March 13, 2018

**RE: Ravenswood-Cooley Landing 115 kV Reconductoring Project (A. 17-12-010)  
Response to California Public Utilities Commission Data Request No.1**

**Attachment 1**  
**PG&E Responses to Data Request No. 1**

**Attachment 3**  
**PG&E Drawing No. 405799 – Existing Tower**  
**Configuration**

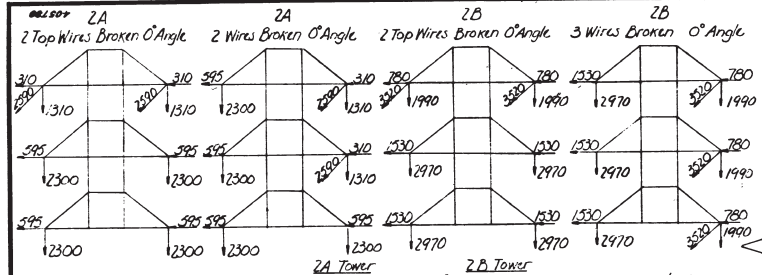
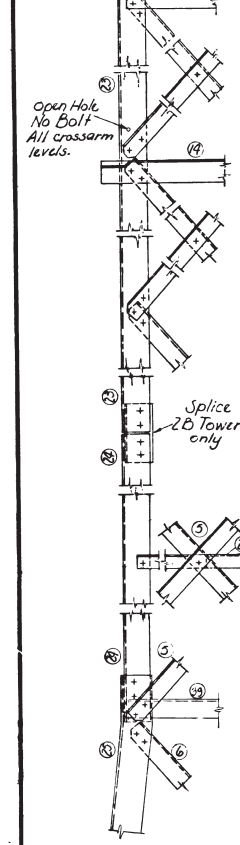
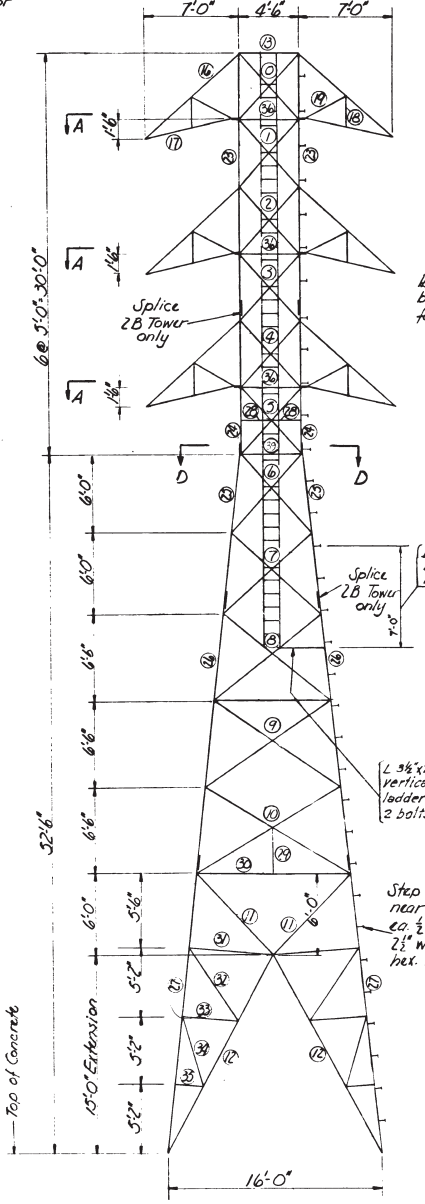
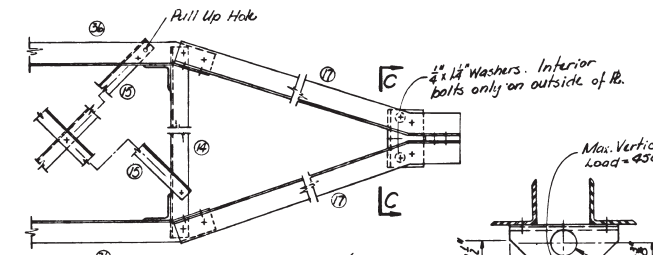
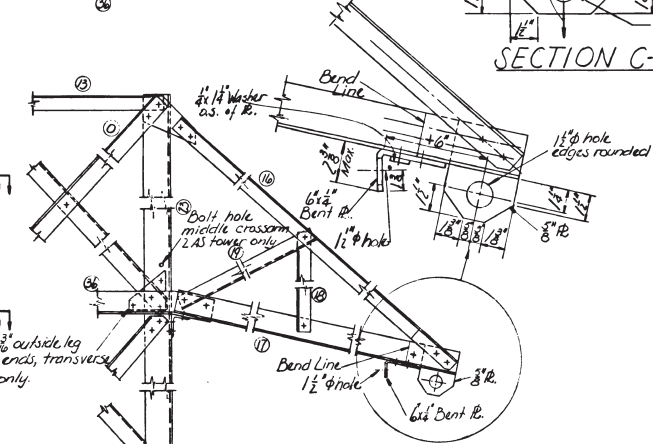
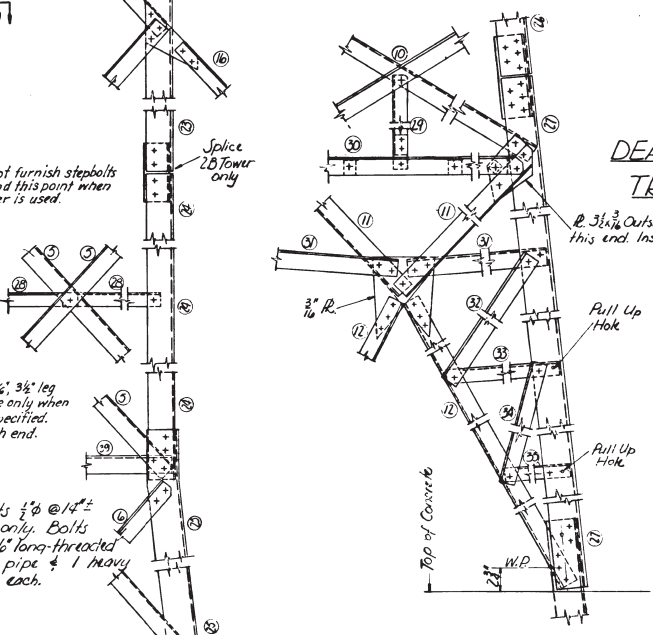
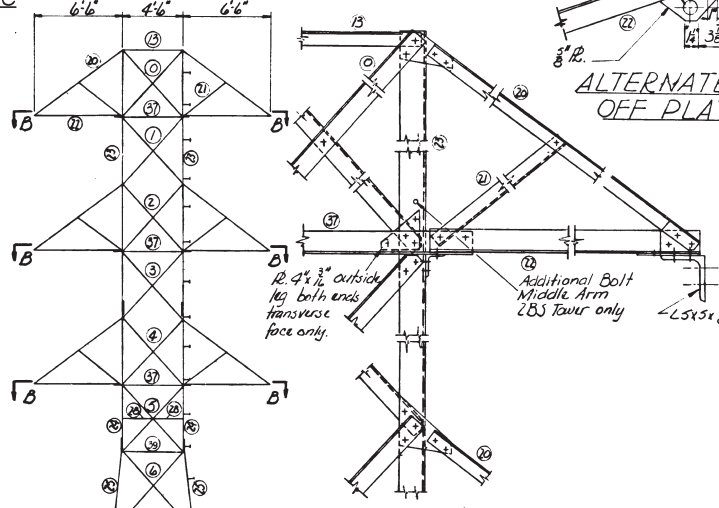
**PD-1** PEA Section 2.5.1 states that the proposed project would require replacing both the conductors and insulators, and provide spacing between conductors both horizontally and vertically. Would the proposed changes to the conductors and insulators affect the spacing between the conductors and potentially require changes to the towers in order to maintain GO 95 spacing requirements? Show tower structure and dimensions.

**PD-2** Section 2.5.2 states that all towers required modification. Please provide the existing, and modified tower configurations, dimensions, and measurements.

**PG&E Response:** The reconducted power line will maintain GO 95 spacing requirements between conductors; no changes to the towers will be required to maintain GO 95 spacing. For existing and proposed tower structures and dimensions, please refer to PG&E’s Response to California Public Utilities Commission Review of Application Completeness, dated February 15, 2018, Attachments 5 and 6. For ease of review, the typical drawings referenced in the February 15, 2018 letter are included as Attachments 3 and 4 to this response.

**PG&E Response:** Please refer to Table 1 for existing and proposed tower heights. For existing and proposed tower structures and dimensions, please refer to PG&E’s Response to California Public Utilities Commission Review of Application Completeness, dated February 15, 2018, Attachments 5, 6, and 7. For ease of review, the typical drawings referenced in the February 15, 2018 letter are included as Attachments 3, 4, and 5 to this response.

**Attachment 6**  
**Cooley Landing Substation Single-line Diagram and**  
**General Layout**

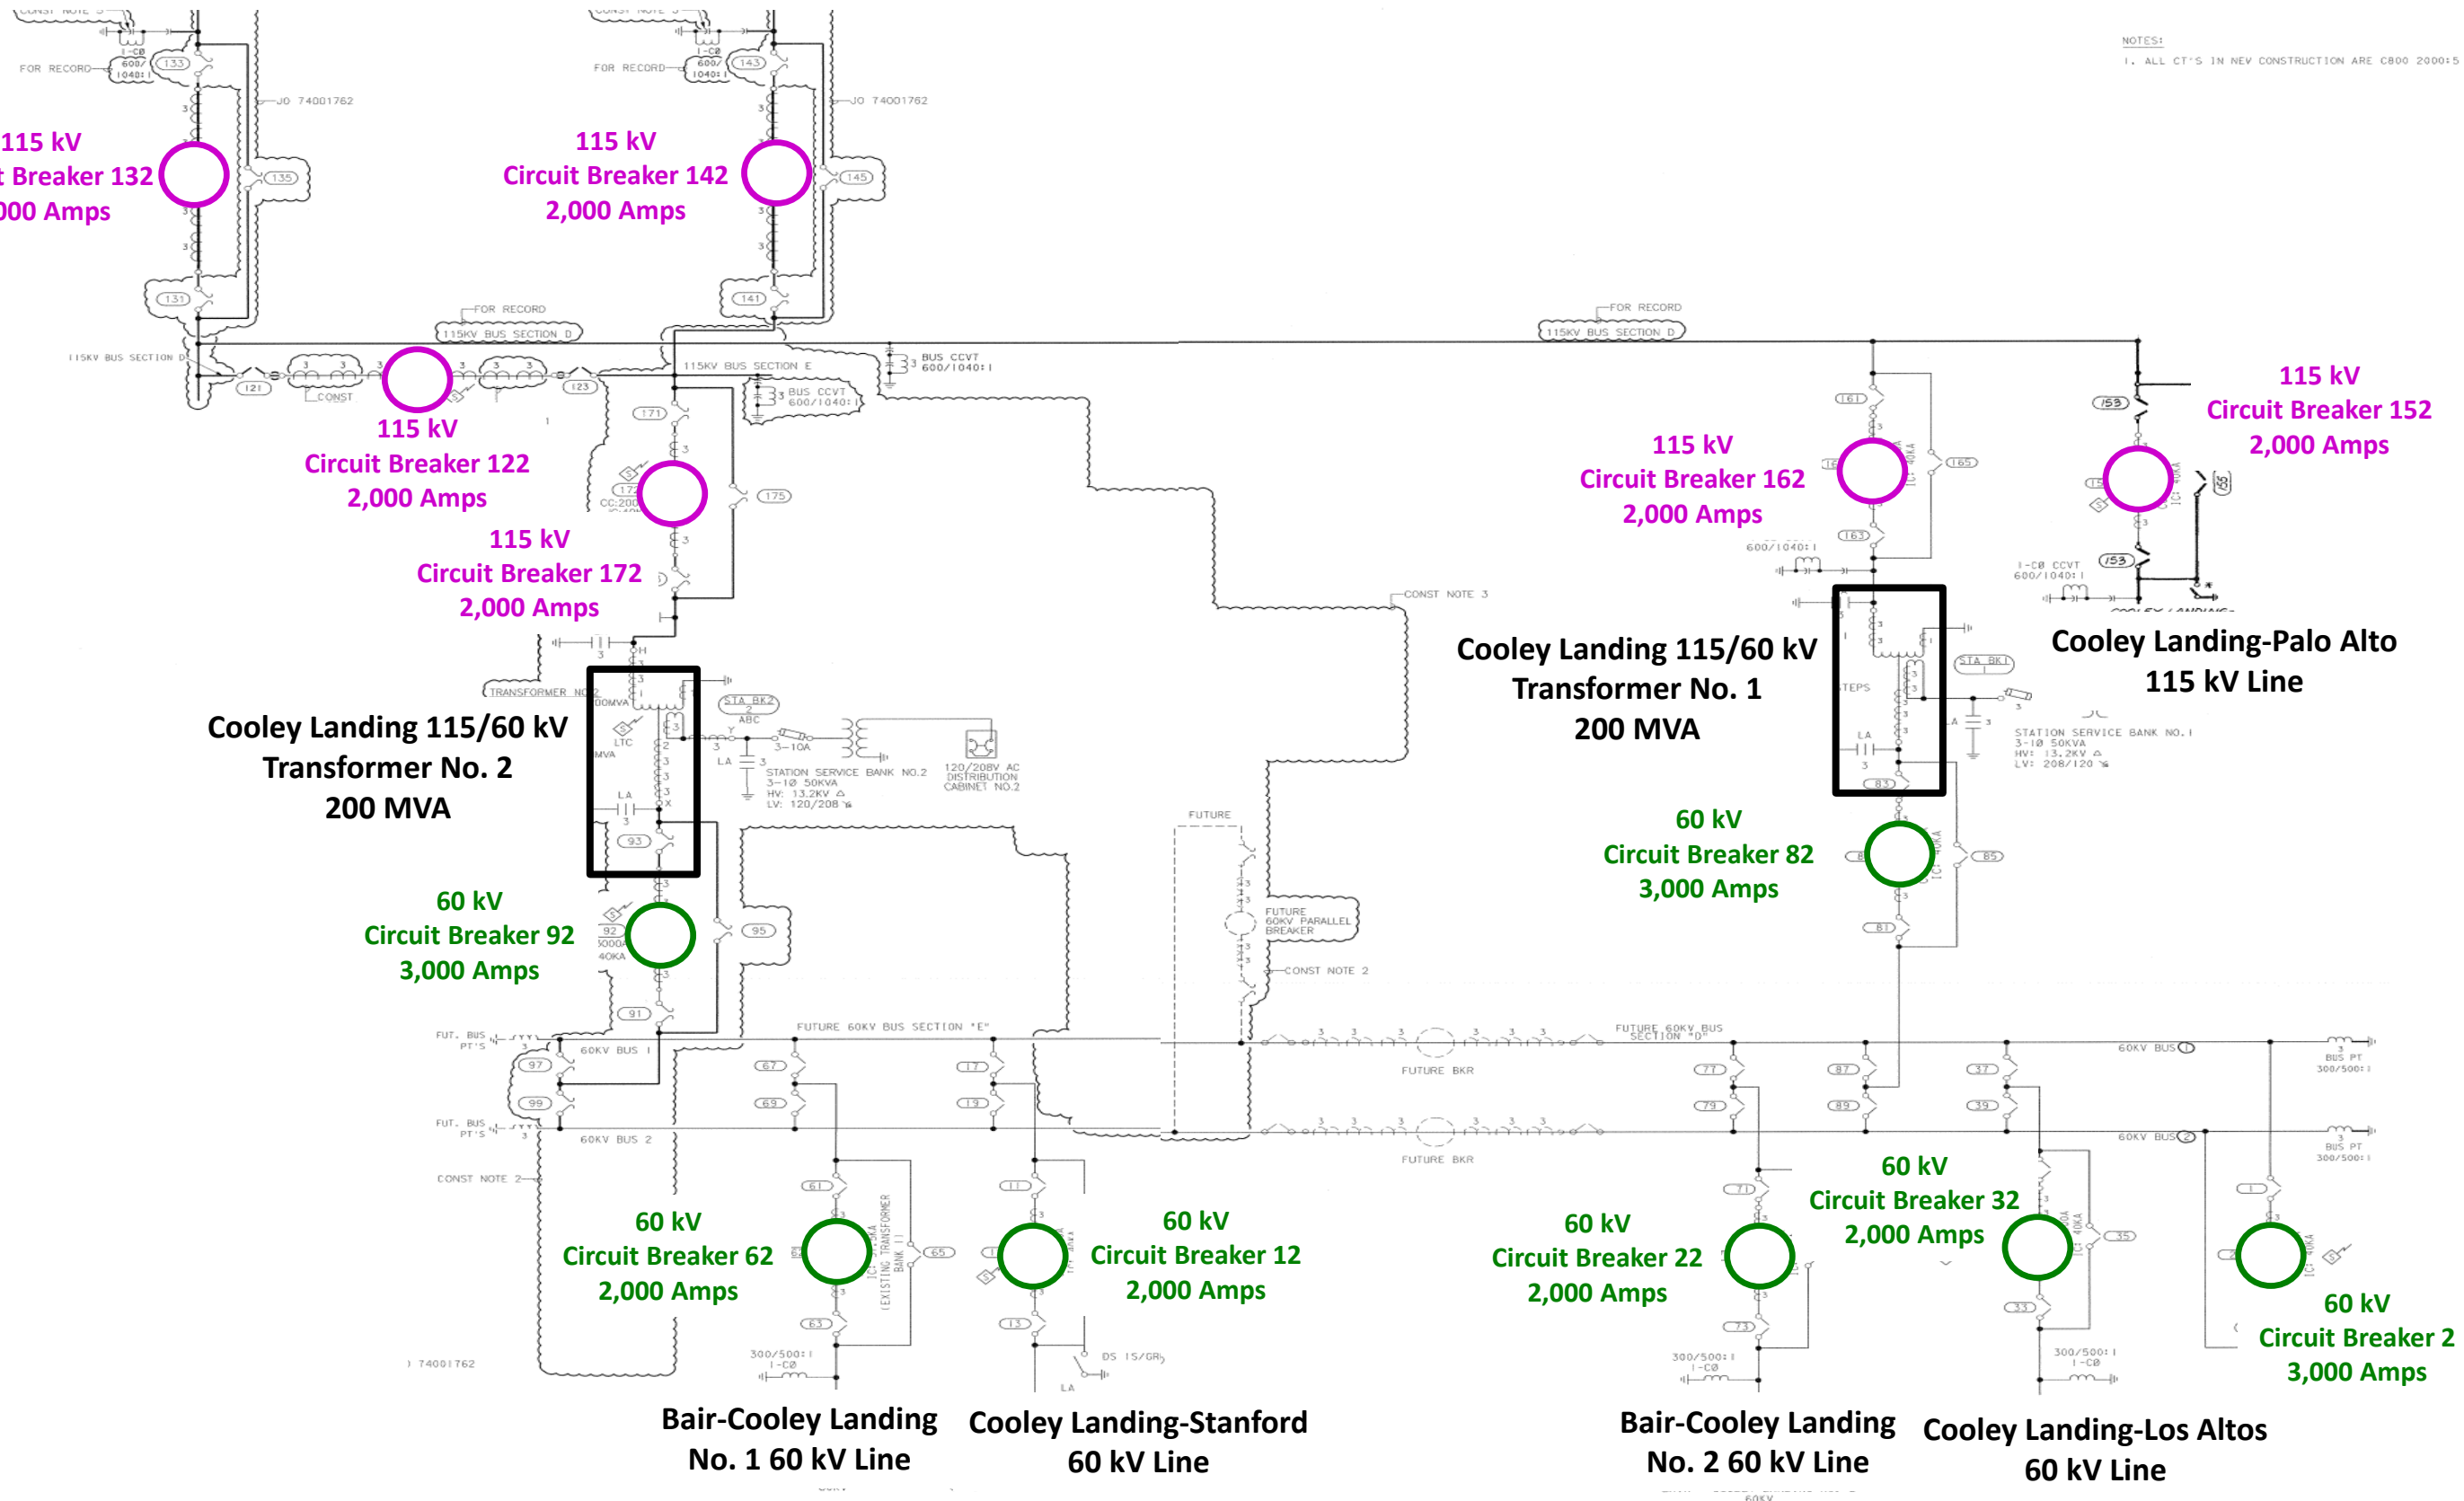
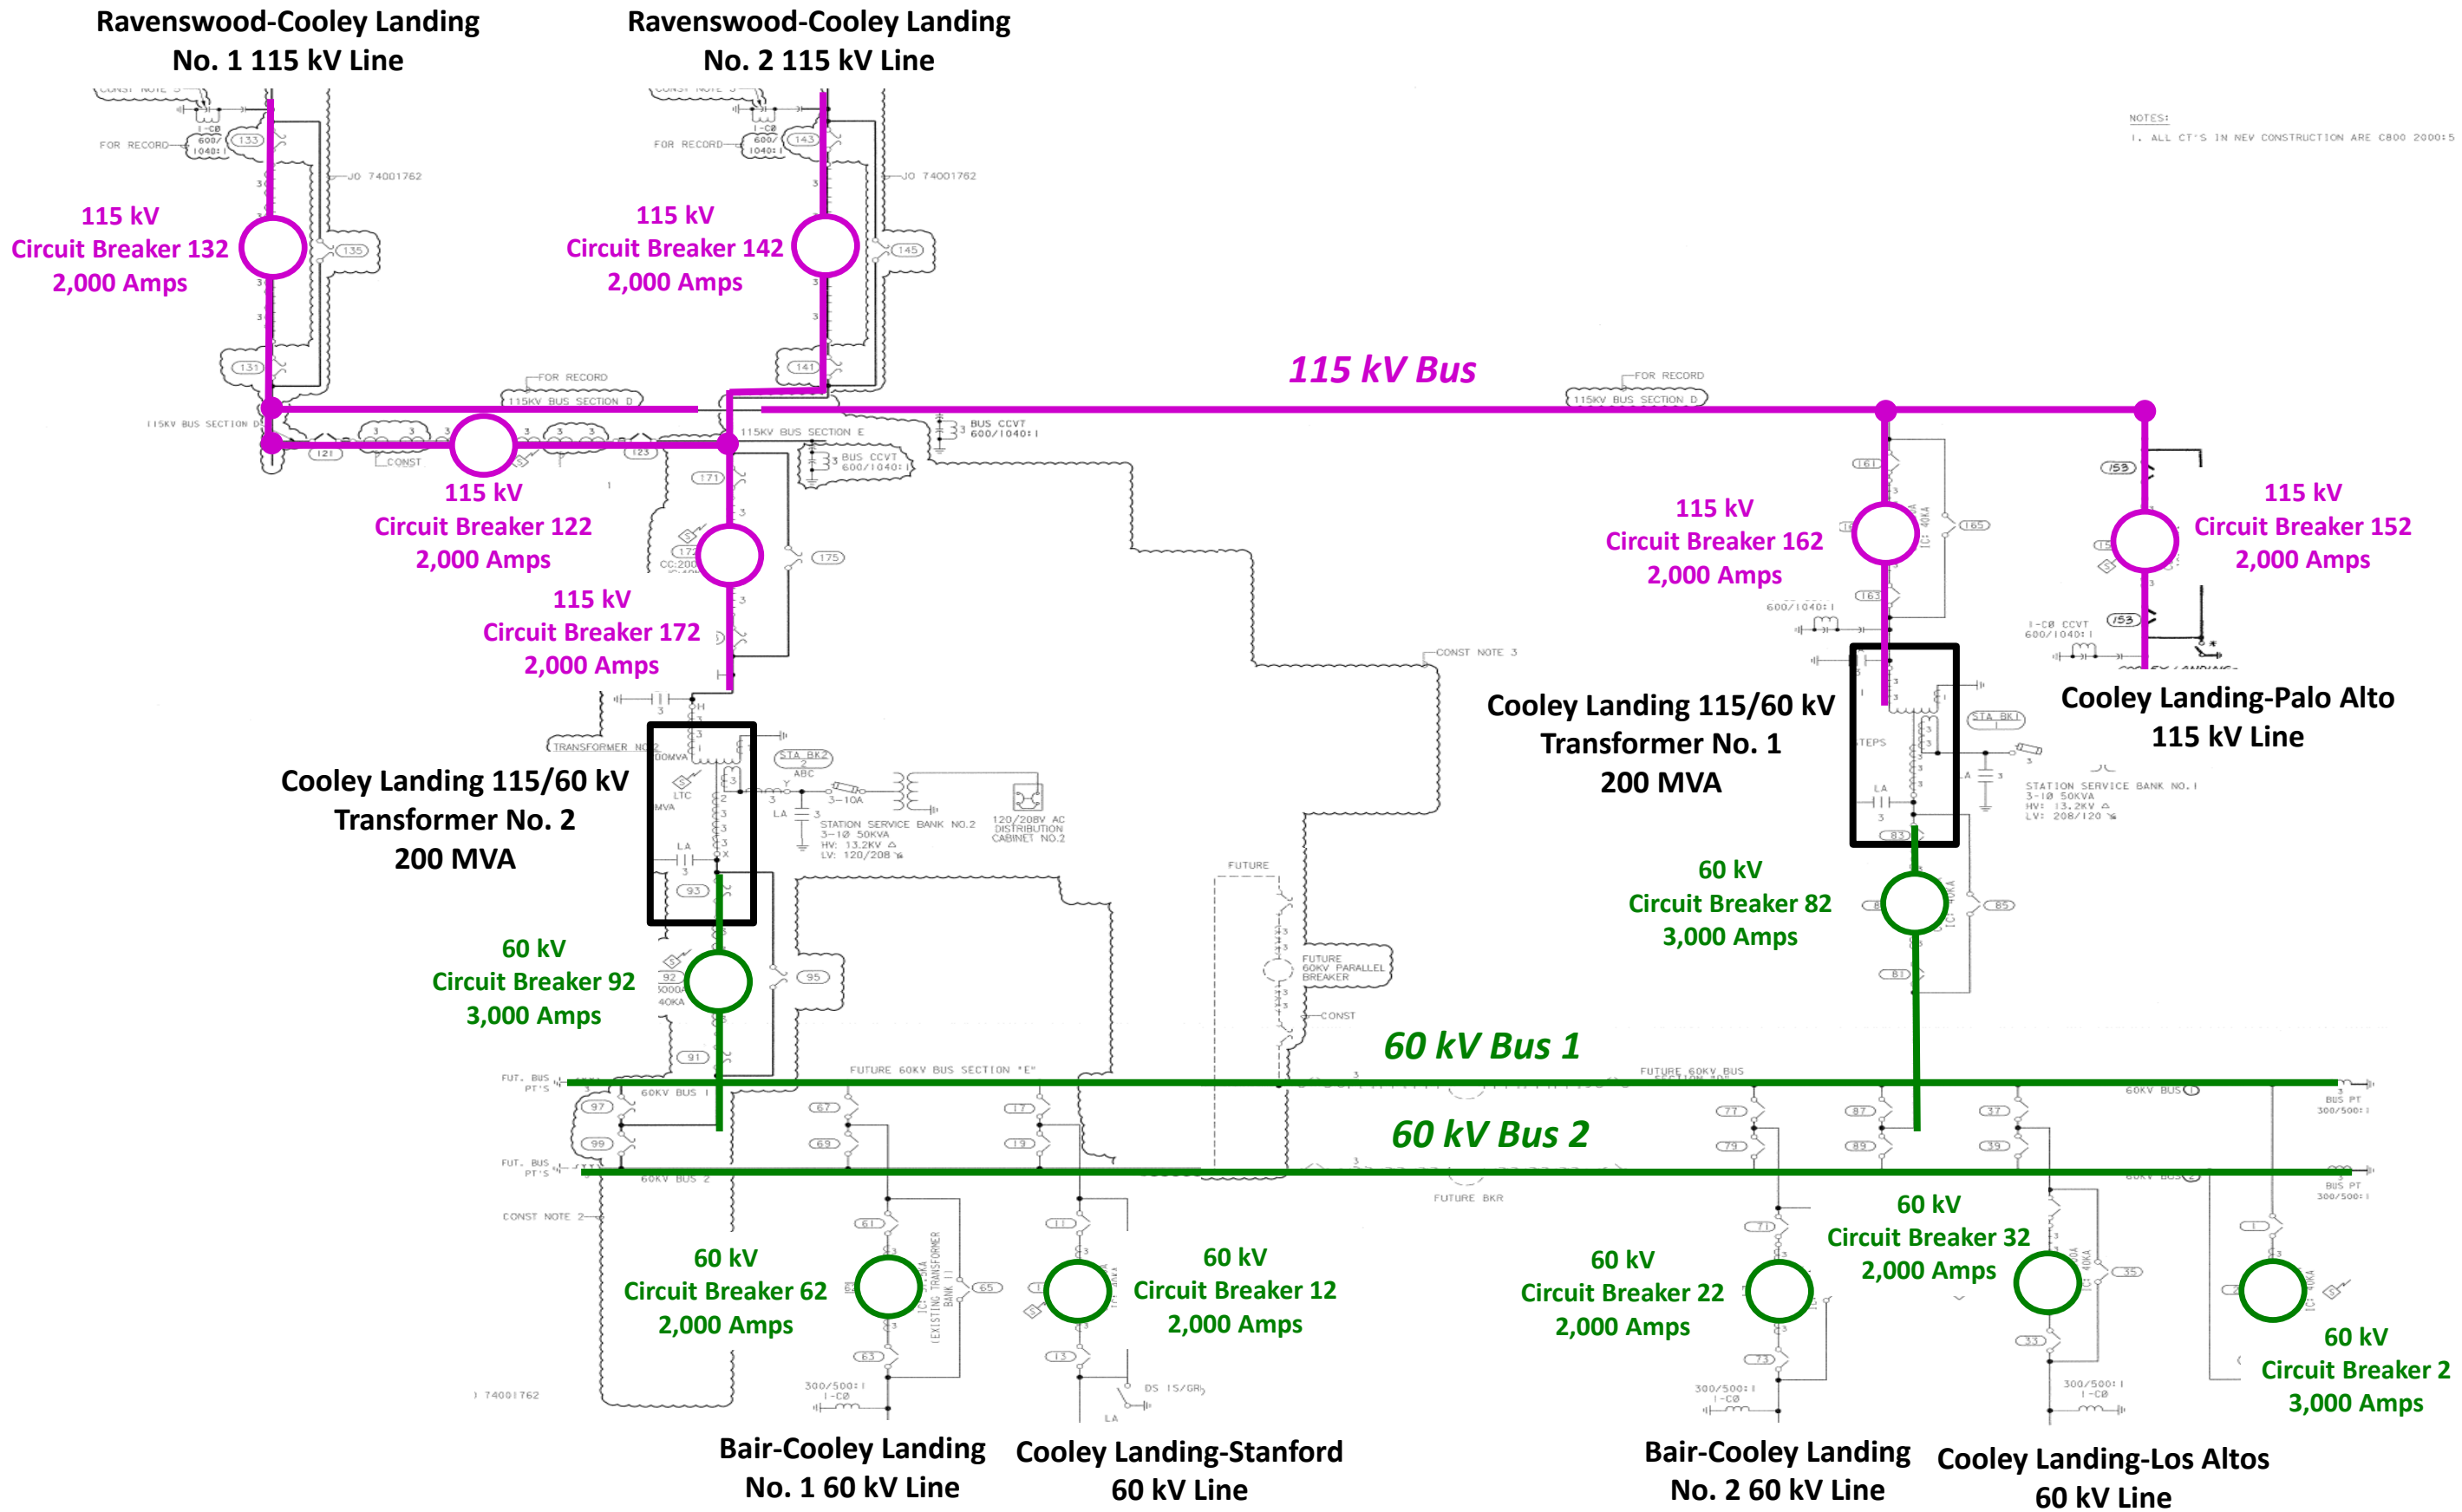
**PD-3** PEA Section 2.5.5 discusses a modification will be required in the Cooley Landing Substation. Please provide one-line diagrams of the Cooley-Landing substation. Please show bay arrangements and breaker ratings.

**PG&E Response:** Please refer to Attachment 6 for the single-line diagram of Cooley Landing Substation showing the breaker ratings, the general arrangement map showing the locations of existing bay arrangements and existing Circuit Breaker 122,

and the new optical fiber ground wire (OPGW) line termination point at the existing control building.
